South Texas Project Electric Generating Station 4000 Avenue F - Suite A Bay City, Texas 77414

August 12, 2008
ABR-AE-08000061

South Texas Project
Units 3 and 4
Docket Nos. 52-012 and 52-013
Response to Requests for Additional Information

Attached are responses to NRC staff questions included in Request for Additional Information (RAI) letter numbers 31, 34, 39, 40, 49, 50 and 52 related to Combined License Application (COLA) Part 2, Tier 2 Sections 2.4S and 2.5S. This submittal includes responses to the following Question numbers:

Figure 1 – HEC-HMS Hydrologic Diagram for Scenario 1

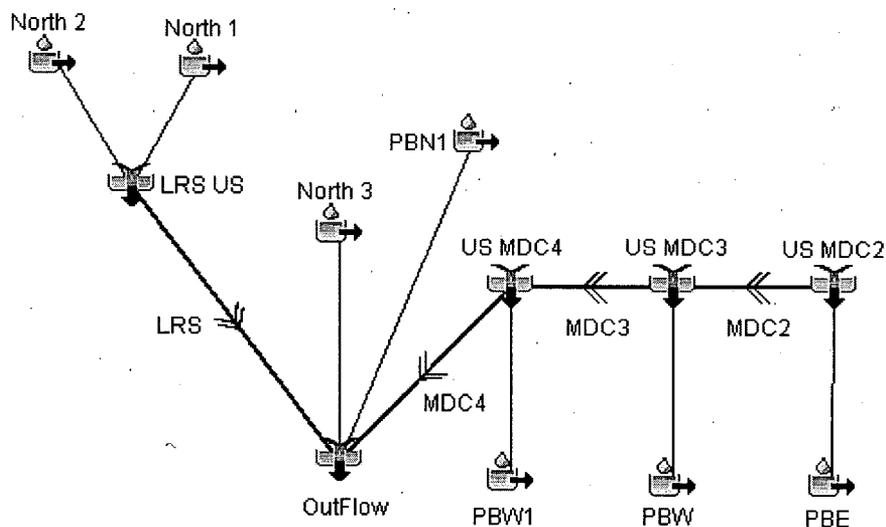
RAI Part 1: Provide a discussion of (A) flood magnitude and timing; (B) the effect on water levels in the power block area; and, (C) the effect of the 34 ft MSL constant water level boundary condition in HEC-RAS simulation, if FM 521 were not to act like a barrier and flood runoff from North 1 and 2 subbasins were not lagged significantly.

In Scenario 1, flood flow from North1 and North2 is assumed to discharge to LRS unimpeded. This is accomplished in the HEC-HMS flood routing model (Reference 1) by assigning a junction element, instead of a reservoir element as in the COLA base case, at the FM 521 crossing at LRS. The conceptual model for Scenario 1 as represented in HEC-HMS is shown on

The HEC-HMS modeling results of the two scenarios show that Scenario 1 produces a higher flood peak at the junction of LRS and MDC (model junction "Outflow") than Scenario 2 (at model junction "Outflow"). This is primarily a result of the longer time of concentration estimated for the larger subbasin North1A, which has a longer flow path. Consequently, the predicted flood hydrograph for Scenario 1 is used to estimate the maximum water level in the power block area by using the HEC-RAS model previously developed for the COLA base case.

Figure 3 – Precipitation Distribution and Resulting Runoff for Subbasin PBN1

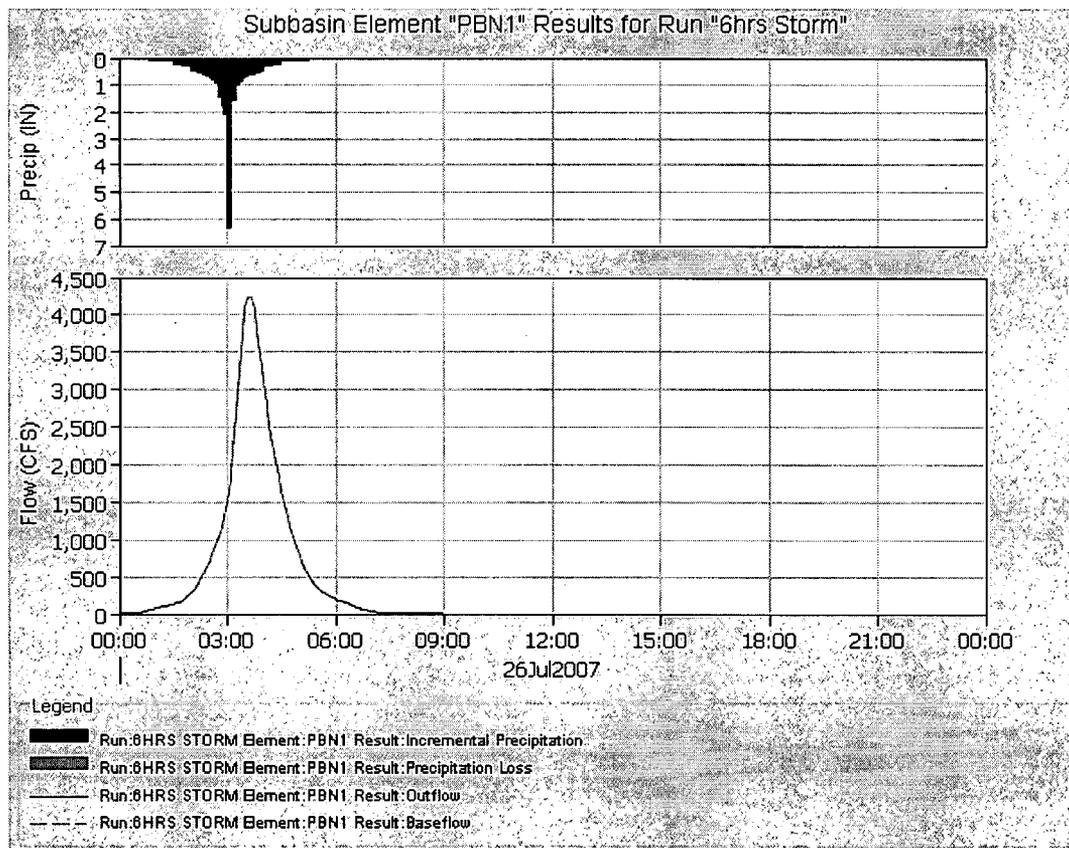
RAI Part 2: Provide justification for using a 6-hr PMP, rather than using a shorter duration and more intense PMP value, to obtain a peak PMF water level in the power block area.

The 6-hr PMP storm used as input to the HEC-HMS flood model is represented by PMP rainfall depths of 5 min, 15 min, 1 hr, 2 hrs, 3 hrs and 6 hrs durations as shown in Table 2.4S.2-4 of Revision 0 of FSAR. The effect of the more intense PMP values corresponding to shorter duration events, down to a 5-minute duration, on the water level in the power block area have been captured in the HEC-HMS and HEC-RAS analyses. Figure 3, which shows the distribution of precipitation intensities and resulting runoff hydrograph for the subbasin PBN1, is provided as an example.

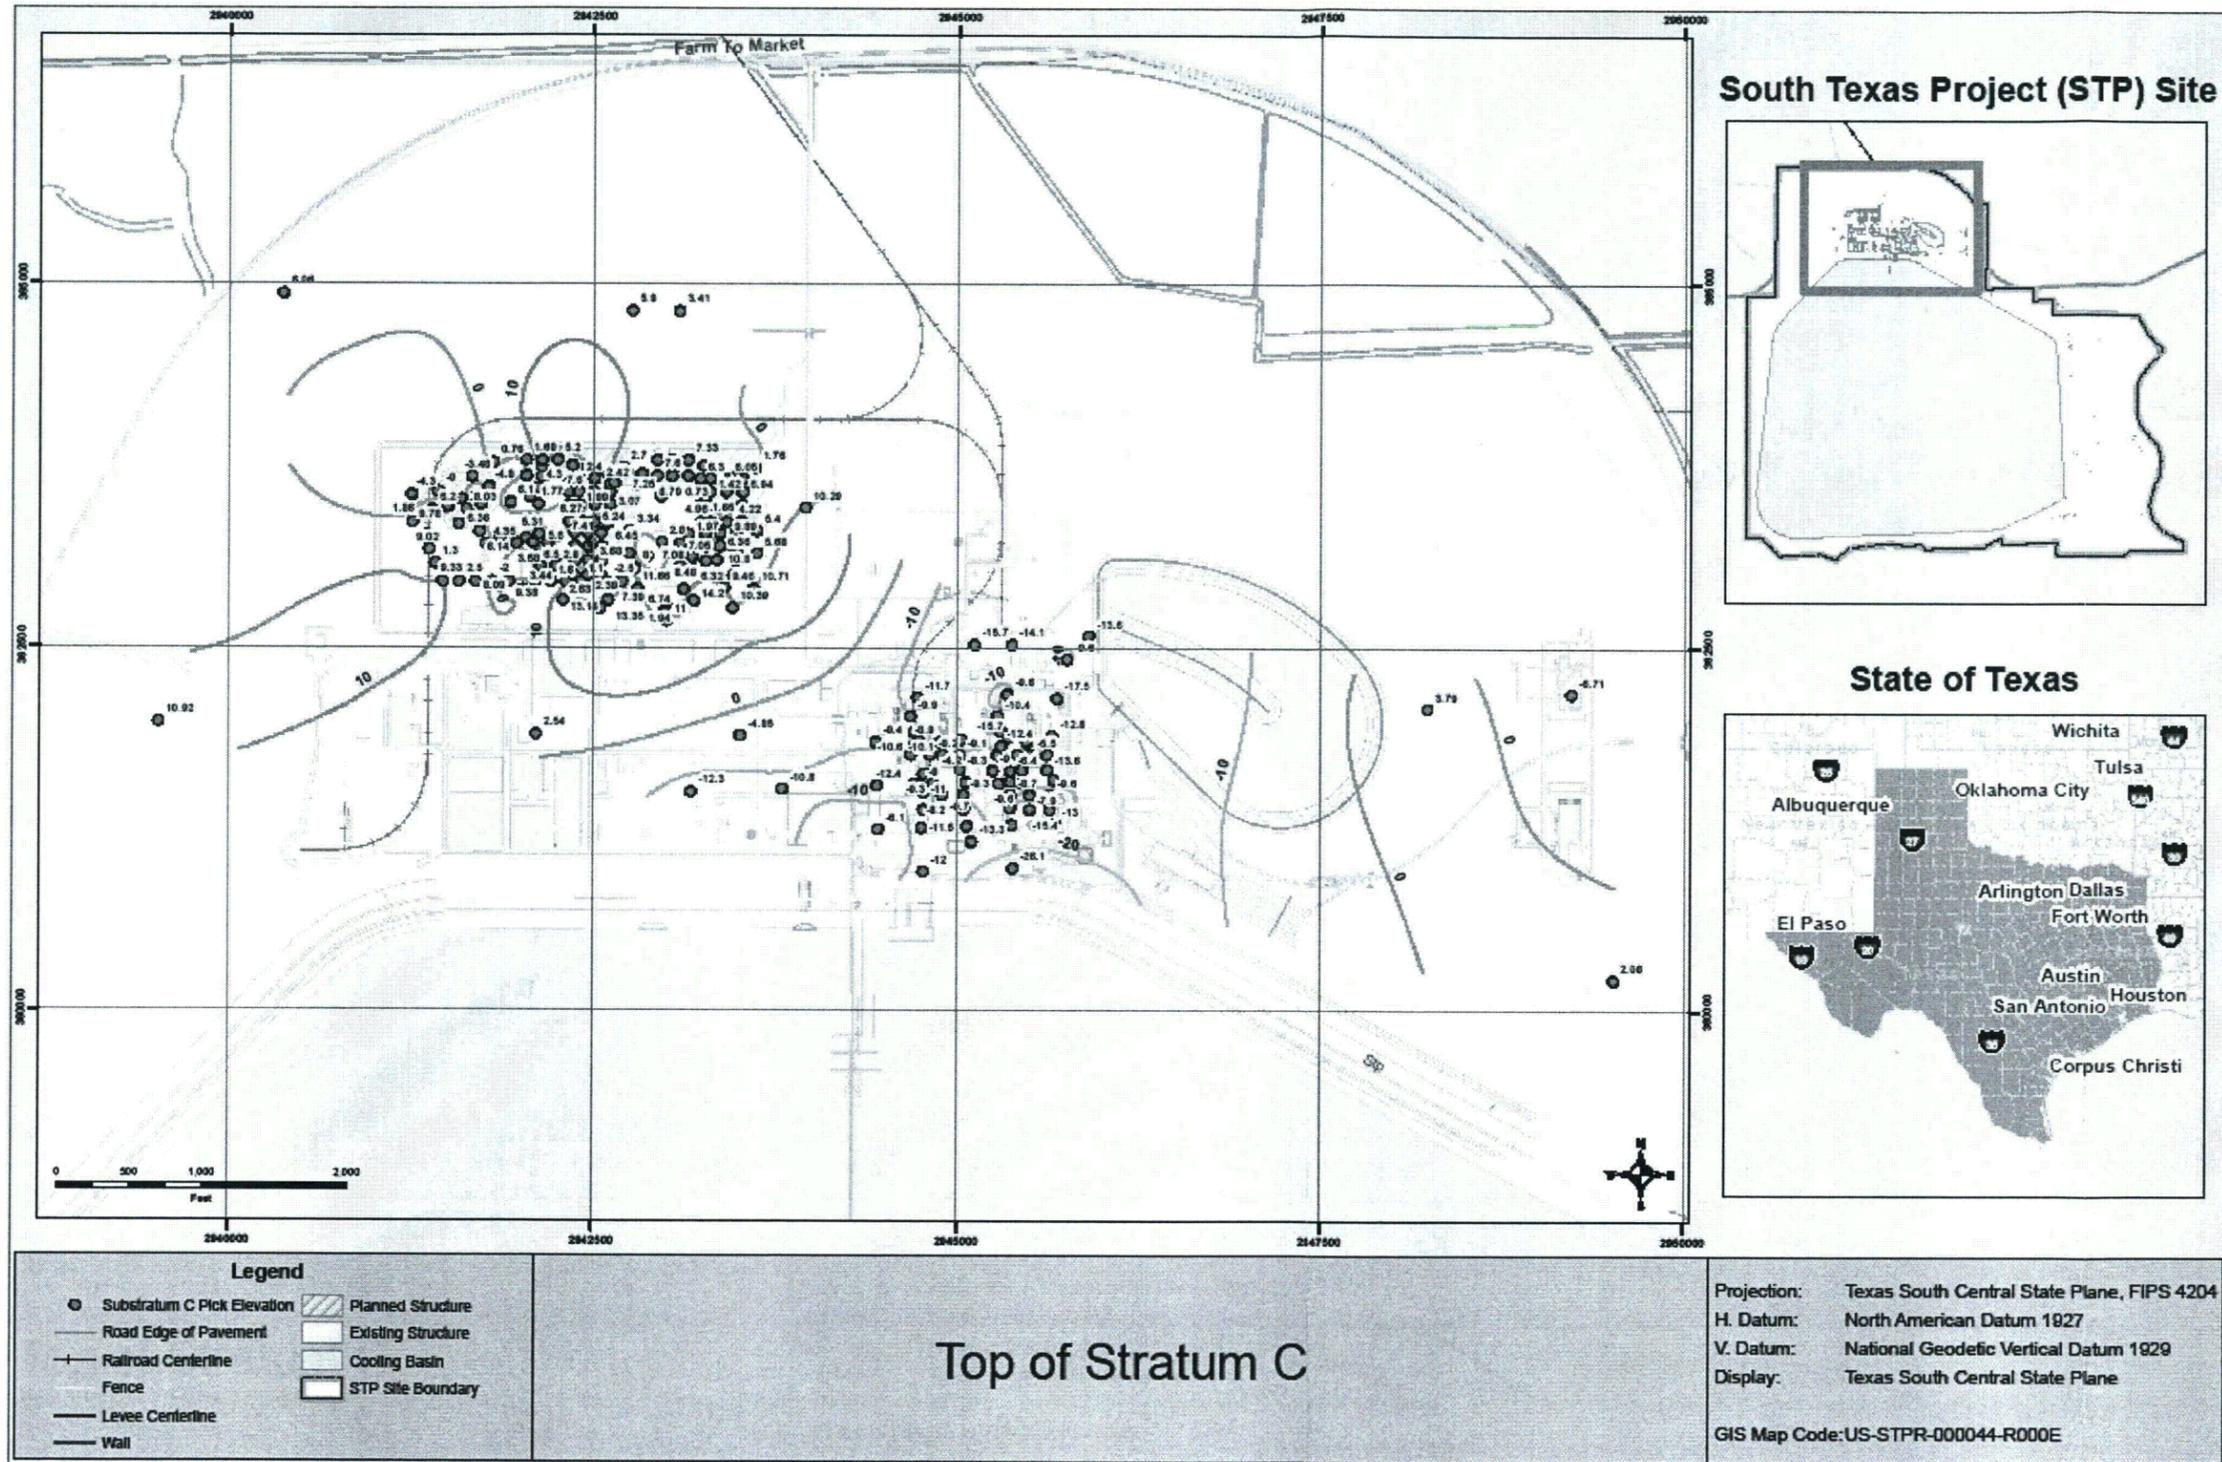
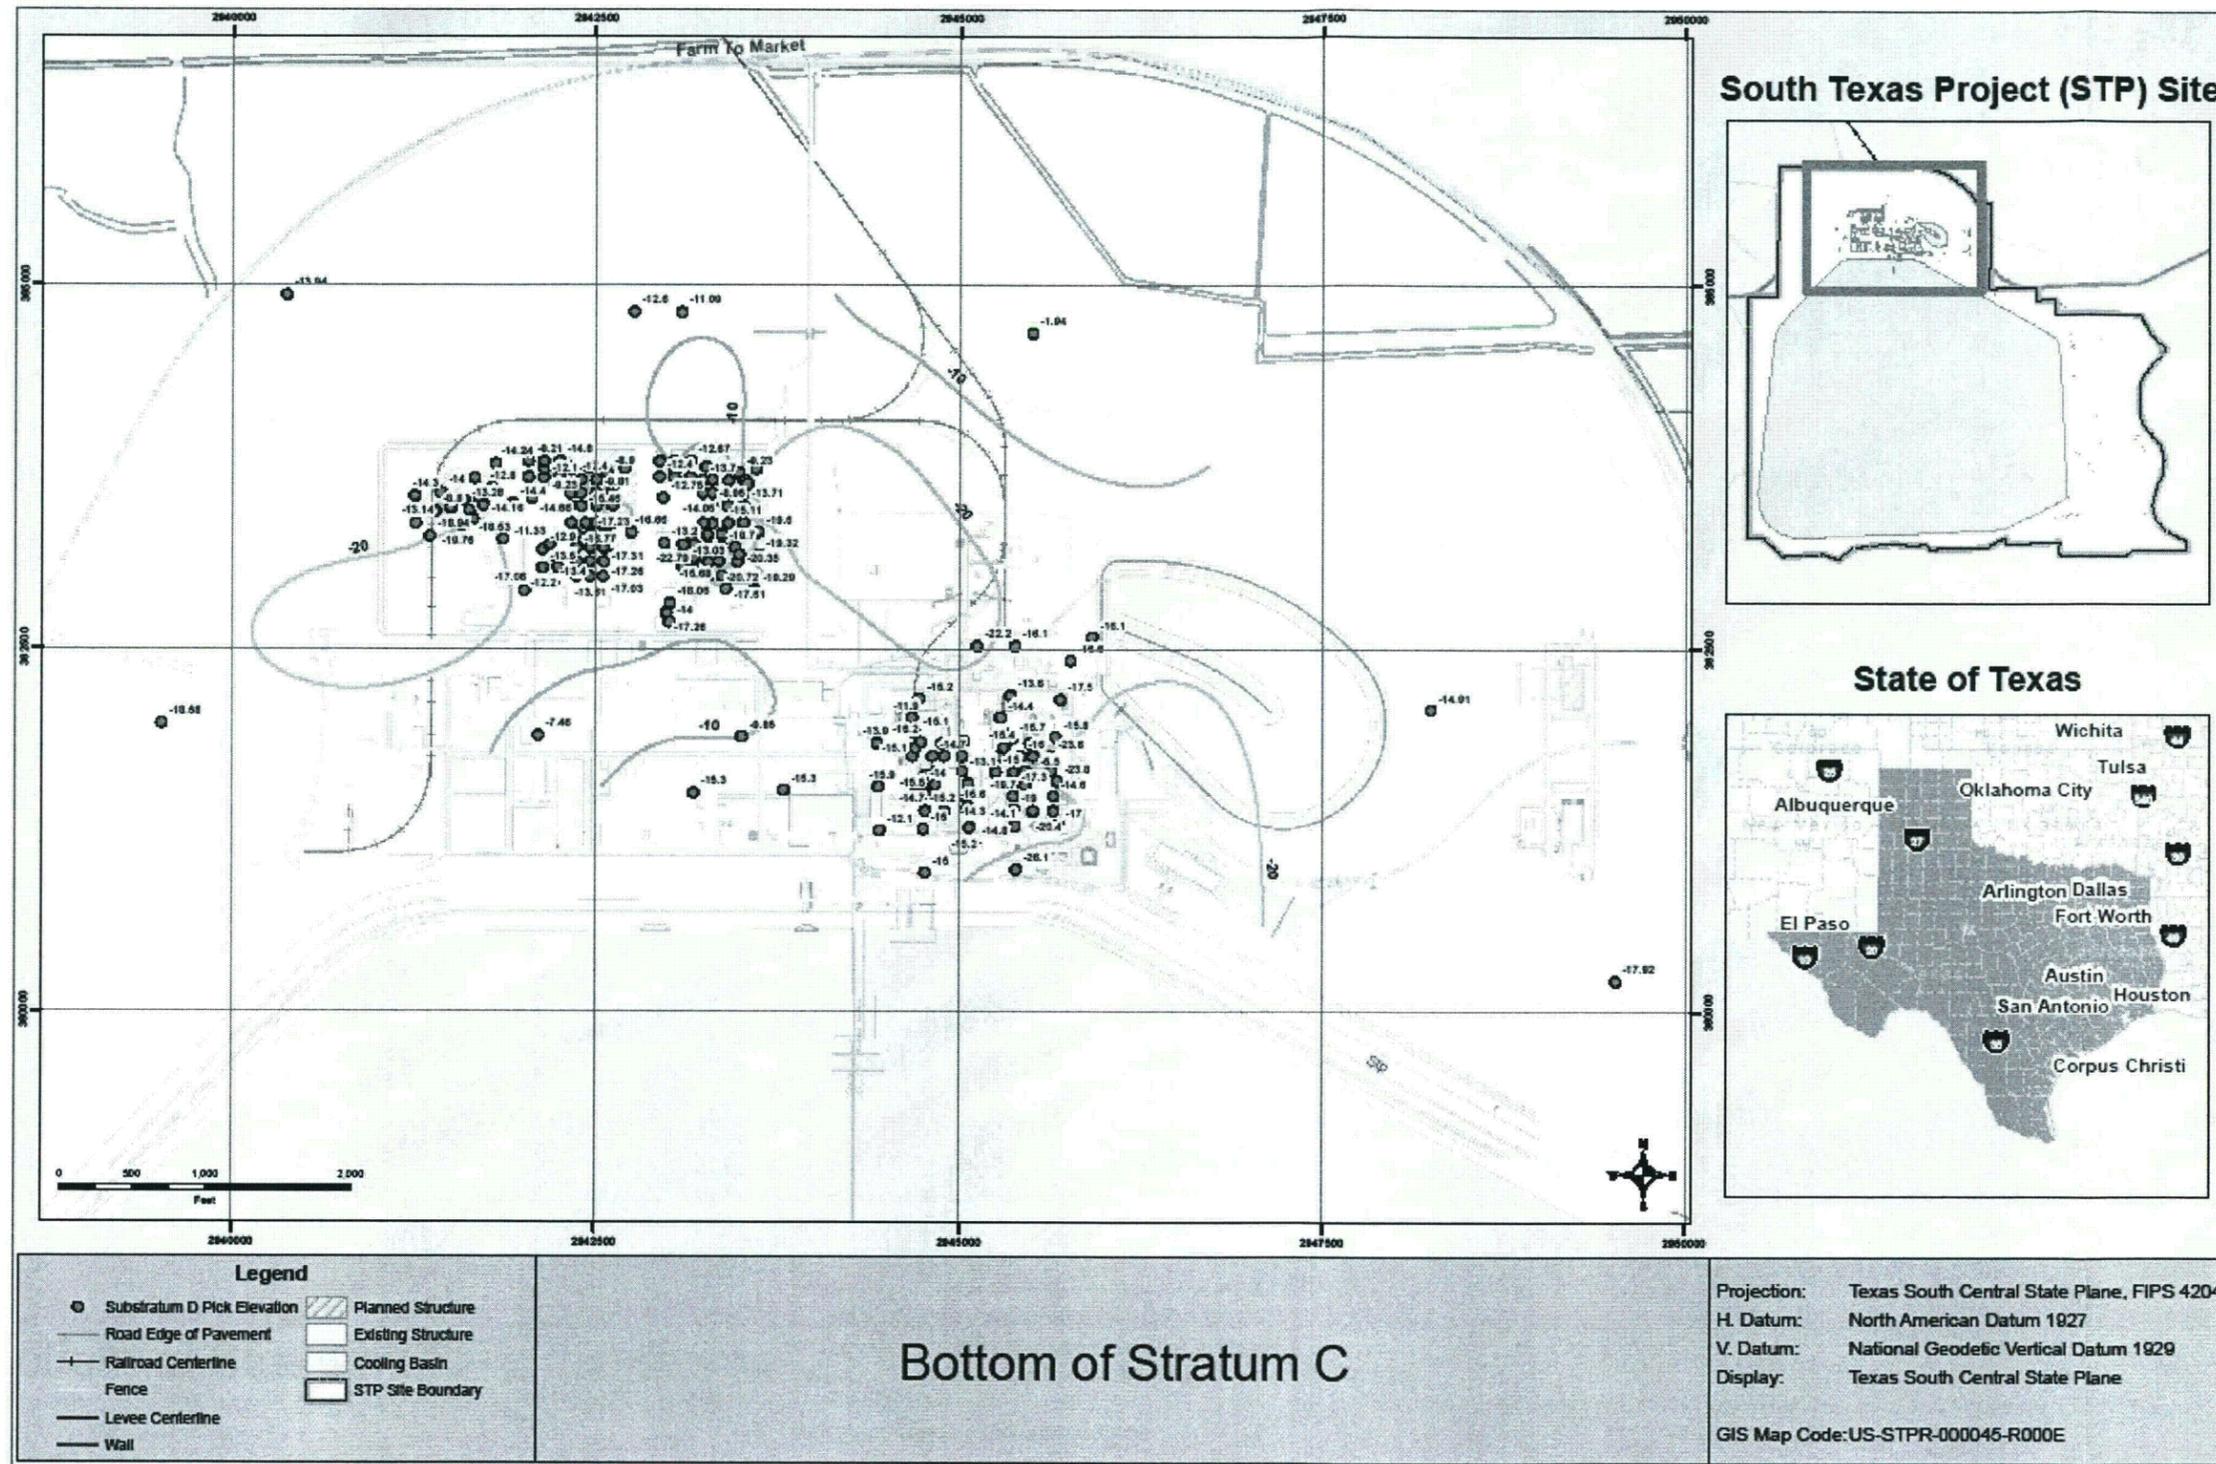
Provide detailed surface maps for top and bottom elevations of both Upper and Lower Shallow Aquifers as they are needed to better understand and predict on-site groundwater flow and pathways. Figure 2.4S.12-10 shows many piezometric wells around Units 1 and 2, but it is not clear whether the water level data from all the wells were used for the water level contour maps in Figure 2.4S.12-19. Please clarify.

The requested maps are attached. The maps are a geostatistical interpretation of available data representing the top and bottom elevations of the Upper Shallow Aquifer (Geotechnical Stratum C from FSAR 2.5S.4) and Lower Shallow Aquifer (Geotechnical Strata E and H from FSAR 2.5S.4). The tension-spline method in ESRI ArcGIS software was used to contour the available data. The data are from the Units 1 & 2 UFSAR (reference) and the STP Units 3 & 4 geotechnical evaluation.

The Lower Shallow Aquifer includes two sand units (Geotechnical Strata E and H) separated in places by a discontinuous clay unit (Geotechnical Stratum F from FSAR 2.5S.4). Where encountered in borings, this clay unit has been observed with a thickness that can range from about 0.7 feet to about 61.5 feet with an average of about 20 feet. However, the encountered thickness at most borings is between about 10 to 30 feet. (It should be noted several borings did not fully penetrate the unit.)

The water level contour maps in Figure 2.4S.12-19 used the data from the observation wells drilled during the 2006 - 2007 subsurface investigation for Units 3 & 4 (the "Units 3 & 4 wells"), because this was the only relevant data available for the two dates represented in that figure. The other piezometers shown in Figure 2.4S.12-10 were installed more than 20 years ago. Most of these piezometers no longer exist or relevant construction details are no longer available. The most recent data available from these piezometers are from May 1, 2006. The earliest data available for the "Units 3 & 4 wells" are from December 28, 2006 (Table 2.4S.12-7). These two data sets are not contemporaneous and, as a result, cannot be combined to prepare contour maps such as those in Figure 2.4S.12-19. Plans are underway to install additional observation wells at the STP site to obtain hydrogeologic information in the vicinity of Kelly Lake and to reduce the uncertainty associated with the groundwater flow paths near the MCR and site boundary.
